Service Bulletin No.: D42L-28-02 Rev. 0

Date Issued: 30 May 2012

Title: Transfer Pump Circuit Breaker Change

Figure 1

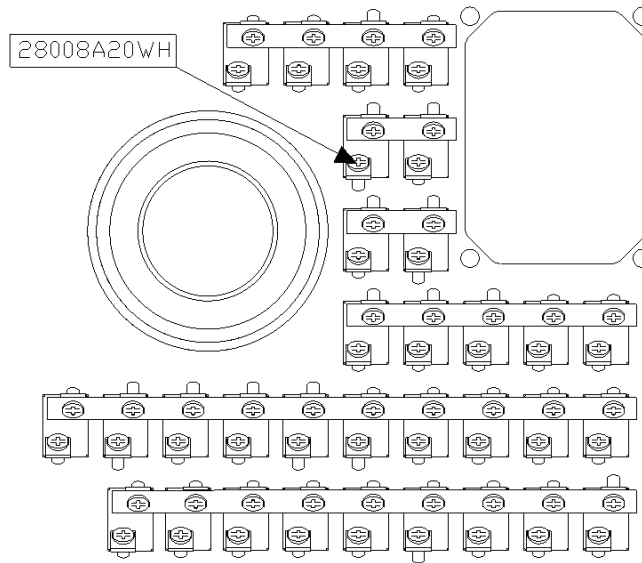
- 10.1 Disconnect the aircraft battery. Refer to AMM # 7.02.01 Chapter 24-31.
- 10.2 Remove the instrument panel cover. Refer to AMM # 7.02.01 Chapter 25-10.
- 10.3 Pull the Battery circuit breaker located on the right side of the instrument panel.
- 10.4 Disconnect wire 28008A20WH from XFR PUMP circuit breaker. Refer to Figure 1.

- 10.6 Remove the 2 position bus bar from the XFR PUMP circuit breaker.
- 10.7 Remove the existing 5A circuit breaker and replace with the 7.5A circuit breaker (P/N MS3320-7.5).
- 10.8 Install the circuit breaker EL panel and air vent.
- 10.9 Secure the instrument panel harness with supplied cable ties (P/N MS3367-4-9), if the existing instrument panel cable ties were cut.
- 10.10 Install the 2 position bus bar to XFR PUMP circuit breaker.
- 10.11 Install wire 28008A20WH to XFR PUMP circuit breaker.
- 10.12 Remove all tools, equipment, and unwanted materials from the work area and inspect for foreign objects.
- 10.13 Install the instrument panel cover. Refer to AMM # 7.02.01 Chapter 25-10.
- 10.14 Connect the aircraft battery. Refer to AMM # 7.02.01 Chapter 24-31.
- 10.15 Do a power check of the Fuel Transfer (XFR) pumps.

Figure 2

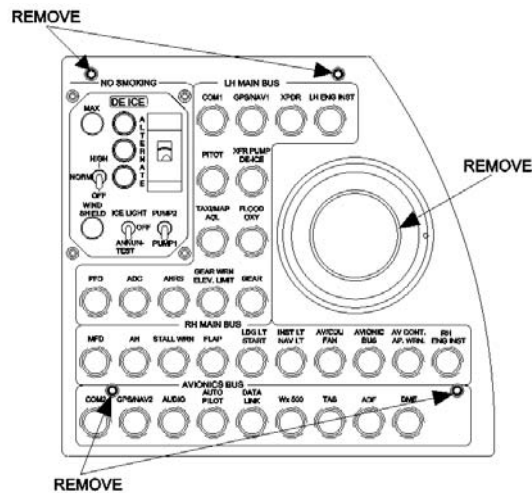
- 10.5 Remove the four mounting screws from the front of the circuit breaker EL panel and remove the air vent. Remove the EL panel. Refer to Figure 2.

NOTE: Cable ties may need to be cut and removed from the instrument panel harness to allow EL panel to be moved clear from circuit breaker nuts.
